**Florida Department of
Environmental Protection
Inspection Checklist**

Facility Name: CITRUS CENTRAL SLF
On-site Inspection Start Date: 12/04/2020
On-site Inspection End Date: 12/04/2020
WACS No.: 39859
Facility Street Address: 230 W GULF TO LAKE HWY
City: LECANTO
County Name: CITRUS
Zip: 34461

Routine Operation Inspection for Landfill - Class I

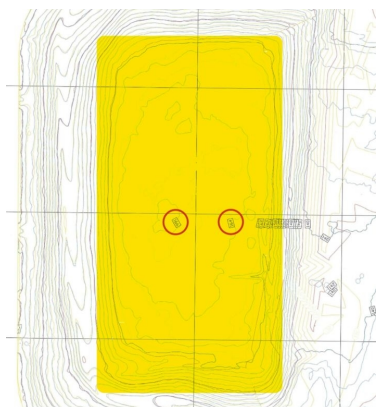
Question Number: 2.13

Explanation: A review of the 2019 topographic survey submitted to the Department with the latest annual estimate of remaining life report indicated that the elevation on the top of Phase I was 166 feet NAVD88 in September 2019, and the elevations of Phase II and III ranged between 120 and 140 feet NAVD88, respectively. At the time of the inspection, it appeared that the facility may not be filling the landfill in accordance with the fill sequence drawings included in the operation plan. Facility personnel indicated that Phase III was currently estimated to be around elevation 150 feet. As detailed in the fill sequence drawings, Step 4 should not have exceeded elevation 134 in Phases II/III and are brought up to elevations between 148.5 and 154.9 in fill sequence Step 5. However, during the inspection, it did not appear that waste between the elevations of 166 and 180 feet were observed in Phase I, which is also part of fill sequence Step 4. Discussion between the Department and facility personnel following the inspection indicated that a topographic survey of the facility was recently completed in September.

Corrective Action: Within 30 calendar days of the date listed on the attached letter, please provide the Department with a copy of the latest topographic survey of the landfill. In addition, please provide the following information to the Department:

- A) Photo documentation indicating that waste filling on the top of Phase I to elevation 180 feet has commenced and information detailing the approximate completion date of waste filling in this area, or;
- B) Documentation indicating if the facility would like to seek a permit modification to change the method and sequence of fill drawings and applicable sections included in the operation plan, and information detailing the facility's timeline to seek this permit modification.
